## PRODUCT CHANGE NOTIFICATION

Date: August 12, 2021  
PCN: PCN LEDIL 173

Subject: PCN 173 - Change of product coating method and ordering code

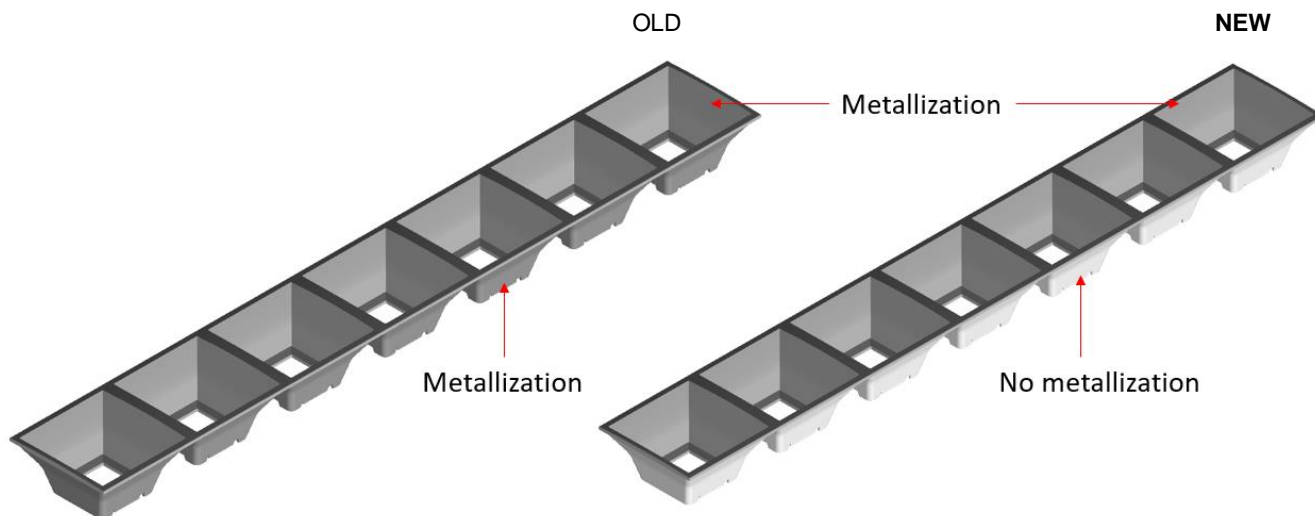
Description: As part of our continuous improvement process regarding product quality LEDiL has changed coating method of C17532\_DAISSY-7X1-SHD-MET from VACUUM EVAPORATION PVD to HMDS.

This change will improve product quality and manufacturability. Mechanical and optical properties remain the same. Bottom side of the new shade will not have metallization.

Changes: Old ordering code: C17532\_DAISSY-7X1-SHD-MET      New ordering code: **C18167\_DAISSY-7X1-SHD-MET**
